**AFTER-ACTION REPORT
2004 NEW BEDFORD HARBOR
REMEDIAL ACTION**
New Bedford Harbor Superfund Site
New Bedford, MA

November 2005

Prepared by
Jacobs Engineering Group
6 Otis Park Drive
Bourne, MA 02532-3870

NO. 0000 DATE: 02/04/04 Figure I-1

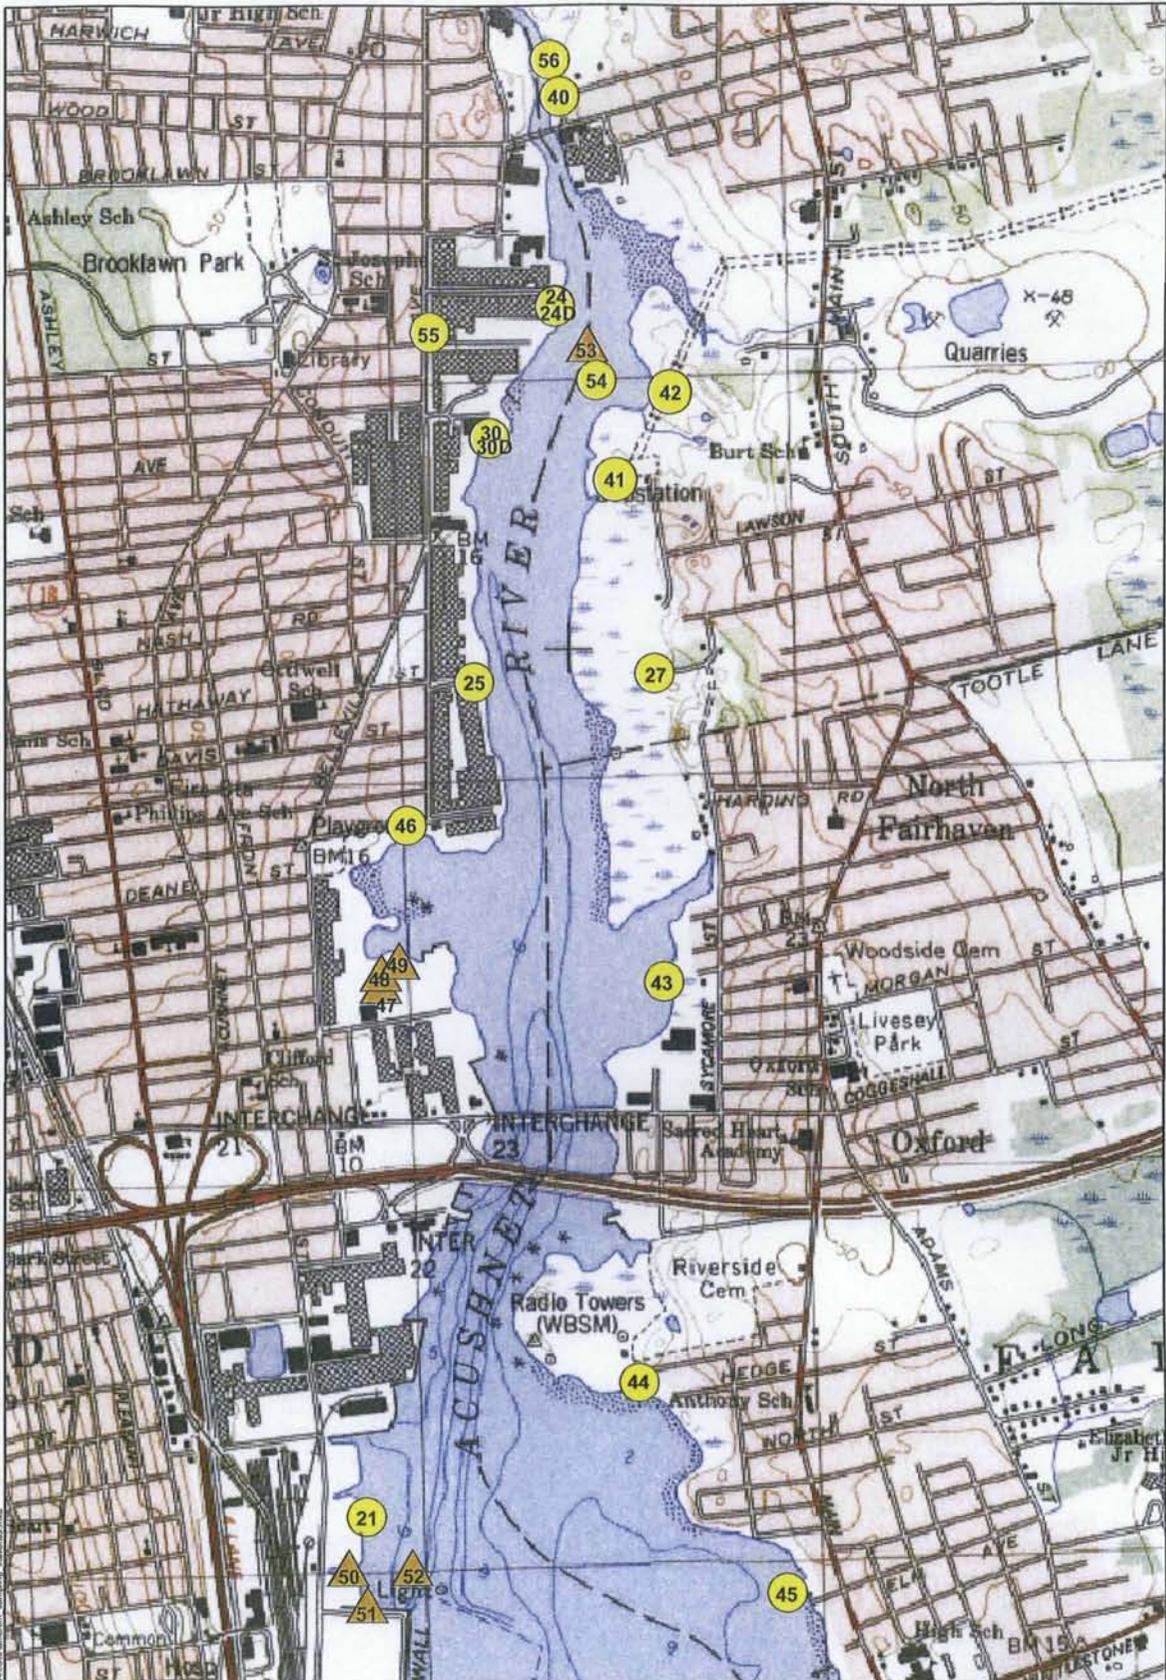
3. Comment: Page 3-3, section 3.2.1, 2nd para. 1st sent. - Table I-1 and Figure I-1 contain more than the 10 station locations that were actually used. Please add a sentence that lists the 10 stations that were used.

4. Comment: Page 3-3, Section 3.2.1, 2nd paragraph, 1st sentence, "...at 10 station locations in Table 1-1 and depicted in Figure 1-1..." - Table 1-1 and Figure 1-1 have more than 10 stations.
